PRELIMINARY & FINAL MAJOR SITE PLAN  
AZ TUCKERTON LLC  
AUTOZONE  
Block 276, Lot 12  
Route 9  
Zone – General Business

Application No. 2017-03A

**RESOLUTION OF APPROVAL 2018-11  
PLANNING BOARD, TOWNSHIP OF LITTLE EGG HARBOR**

Re: T&M File No. LEPB-R2201  
Application No. 2017-03A  
Escrow File No. 522068385  
Preliminary/Final Site Plan – AZ Tuckerton, LLC  
Block 276, Lot 12  
Township of Little Egg Harbor, Ocean County, NJ

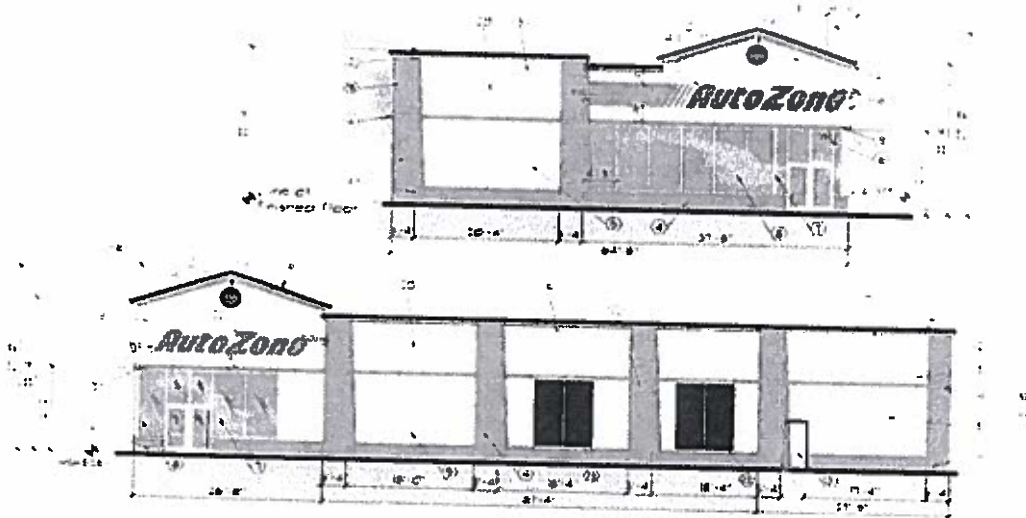
5. We offer concern regarding the building design, given the visually prominent location of the proposal within the Route 9 Gateway Overlay Zone. §15-4.24.3H(3)(a) & (b) requires buildings to have a distinctive design that does *not* represent standard franchise architecture and to have a vertical feature such as an interesting roof form. The applicant proposes a typical, flat roofed, concrete masonry block building, painted grey with orange and red stripes.

We recommend that the applicant modify to the structure to create a building with more traditional architectural forms, materials, and colors, that will complement the architectural vernacular of Little Egg Harbor Township, as required by the Ordinance. A gabled roof or raised decorative cornice could greatly improve the building aesthetics to resemble the more traditional architecture of the Township. We recommend the use of interior grills in windows and complementary façade lighting. The applicant should consider a muted color scheme and breaking up the facades and rooflines as shown below, for a recently approved Autozone in a nearby municipality.
